STUCTURAL PLAN CHECK REPLY FOR

MERLINO RESIDENCE
MERCER ISLAND, WA

Structural, Plan check reply

MERCER ISLAND, WA	
	MERCER ISLAND, WA	
PROJECT NO. 7.74.2020	MERLINO RESIDENCE	
SCALE 1/4" = 1'-0"	UPPER LEVEL FLOOR PLAN	
DATE 2.16.2020		
SHEET NO. A4

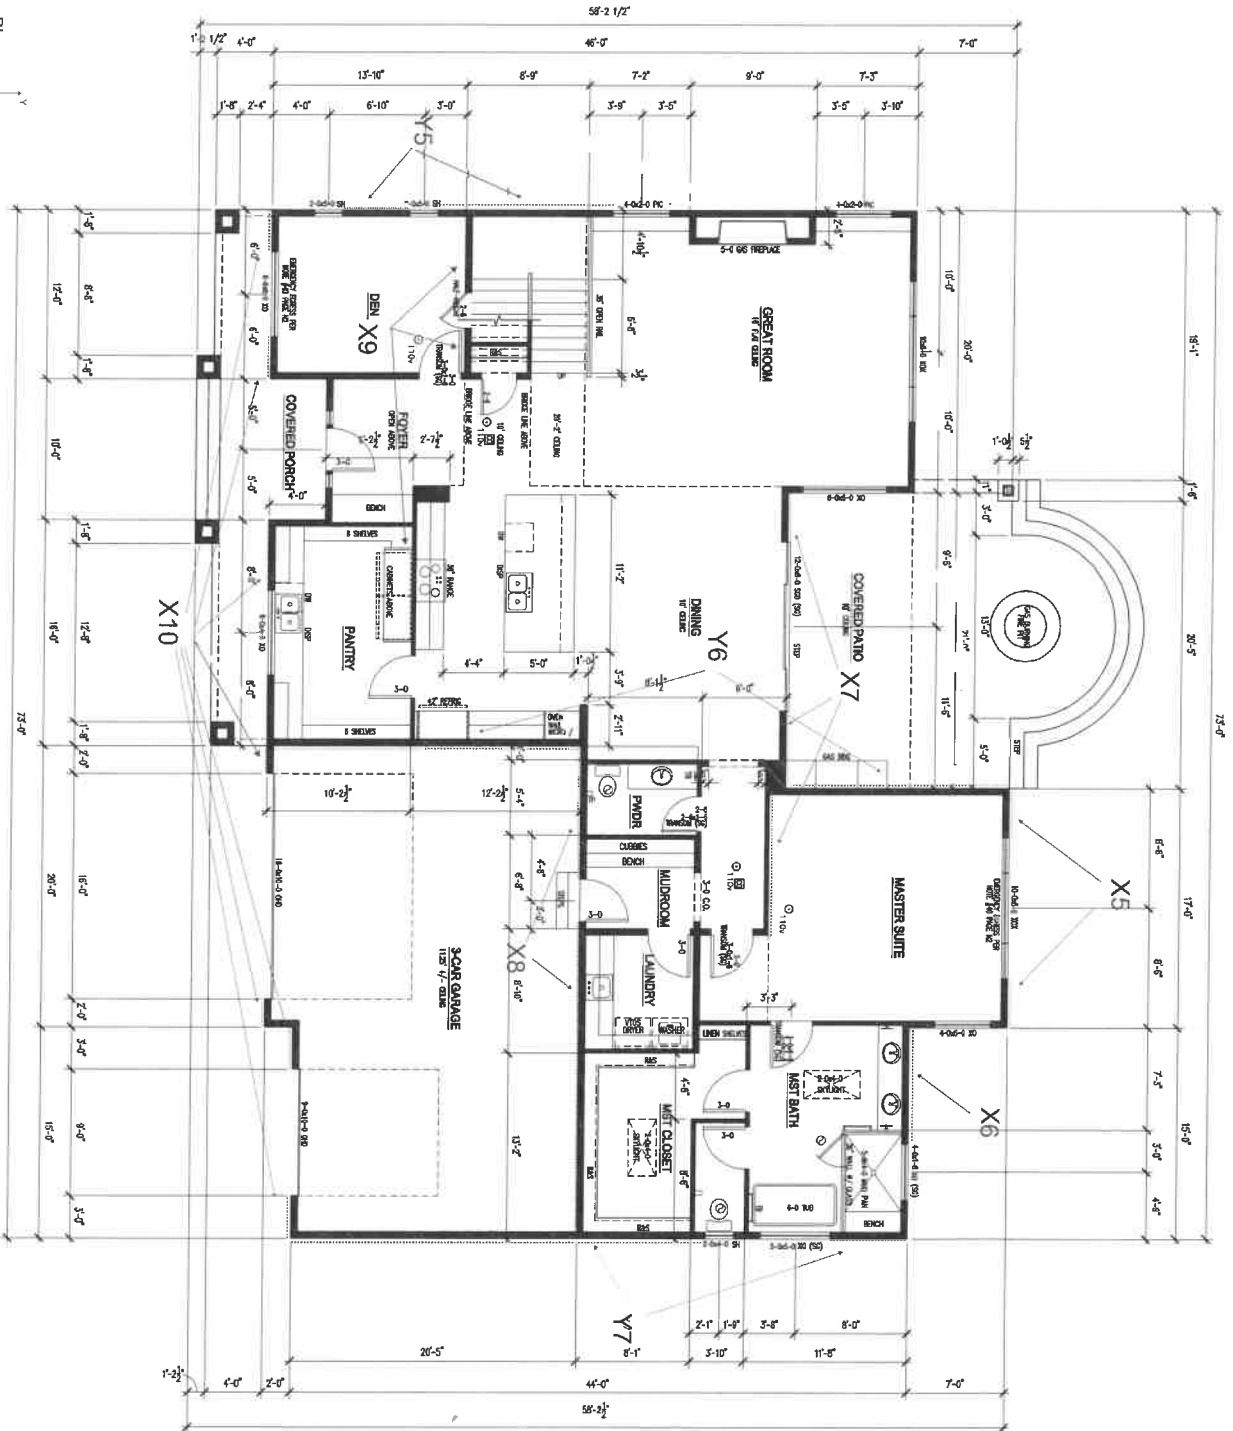
ramps per IRC R308.4.6 or where the glazing is less than 36" above the landing and within 60" horizontally of the bottom tread per IRC R308.4.7. It appears that safety glazing is required at several locations, Sheet A4.

CHECK OVERTURNING FOR: X 1 (Quake)

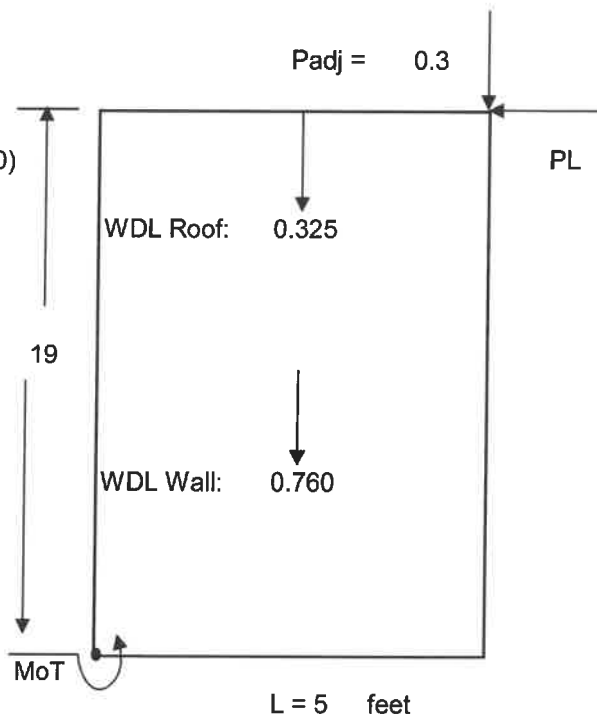
10. Page L14 of the calculations show that holdowns are needed for the X1 shear walls at the upper floor. We do not find these called out on the drawings.

Therefore use STHD14 hold downs at each end

CHECK OVERTURNING FOR: Y 1 (Quake)

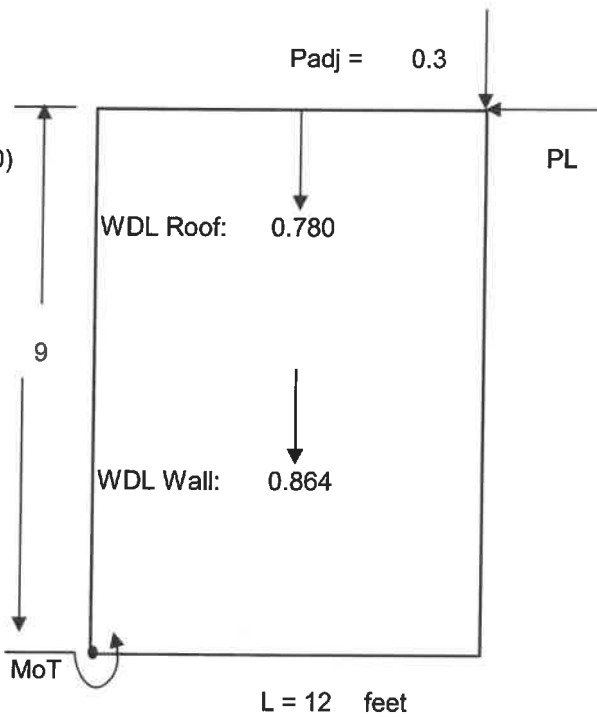
15. Page L17 of the calculations requires holdowns at the Y2 shear wall at the upper floor. We do not find the holdown on the west side of the wall on Sheet A3.
16. Page L18 of the calculations shows holdowns needed for the Y1 shear walls at the upper floor. We do not find these called out on the drawings.
17. Page L19 of the calculations shows holdowns needed for the 4.75' segment of Y5 shear walls at the main floor. We do not find these called out on the drawings.

Therefore use (1)CS16 hold downs at each end

A6 <small>CONTRACT TITLE AND SHEET NUMBER</small>	<small>DATE</small> 7.16.2020	MERCER ISLAND, WA	UPPER ROOF FRAMING PLAN	
	<small>SCALE</small> 1/4" = 1'-0"			
MERLINO RESIDENCE

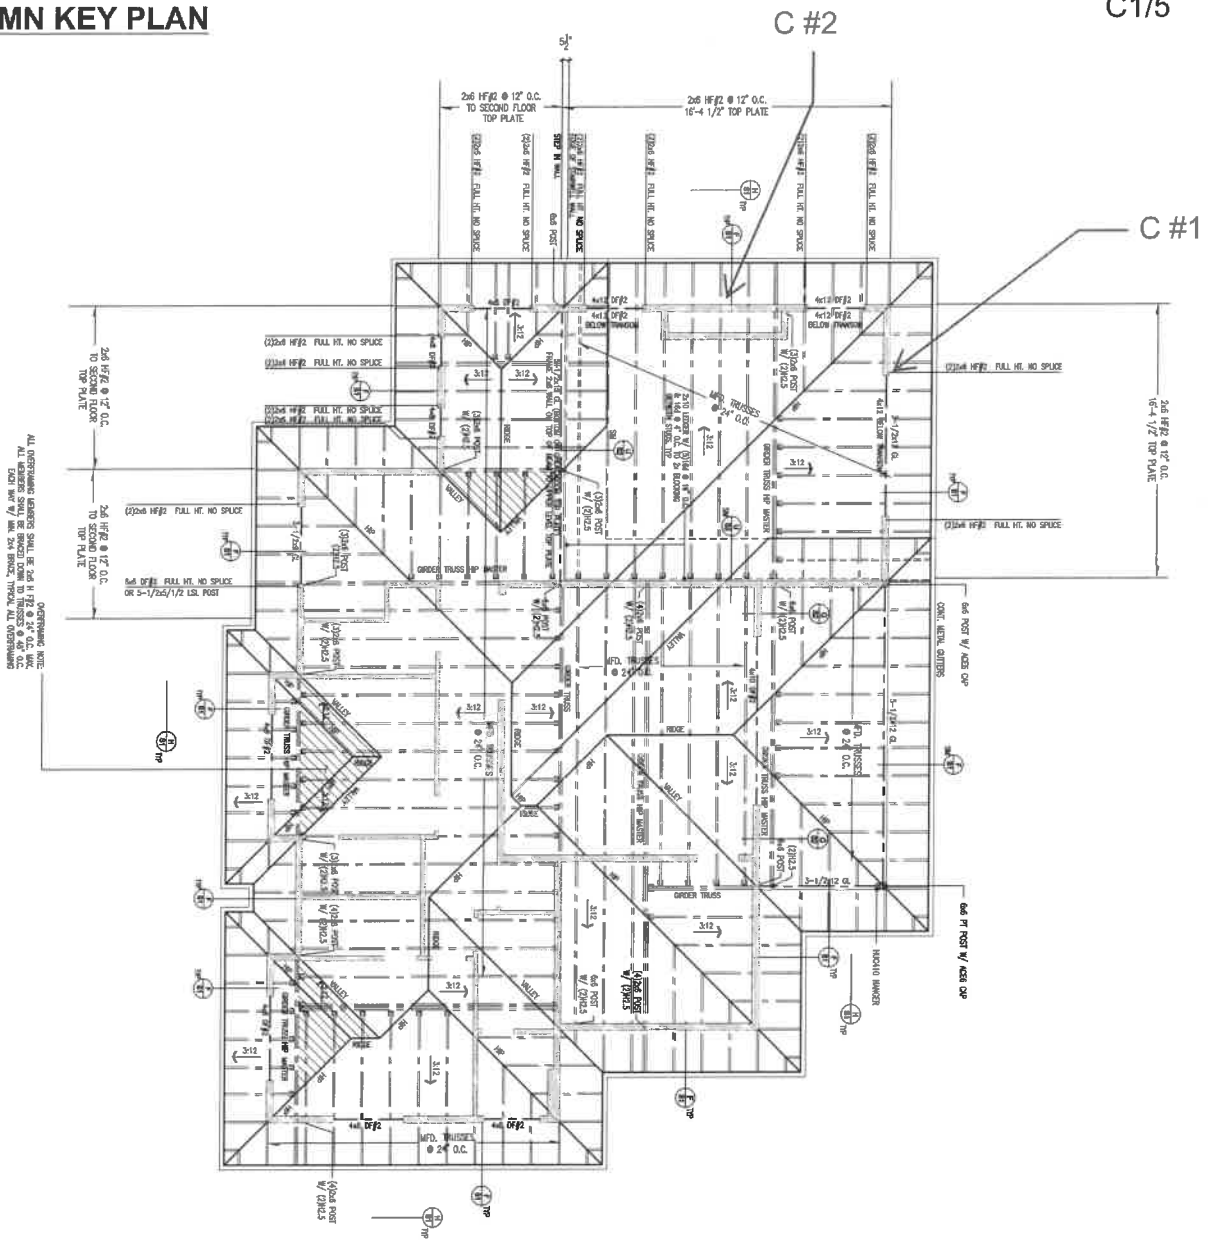
8. Cut a detail on the upper Roof Framing Plan, Sheet A6, at the 10' X3 shear wall to show how lateral forces are transferred into the wall. It appears that Detail WW/S2 is intended; however, it is referenced at the wrong wall.
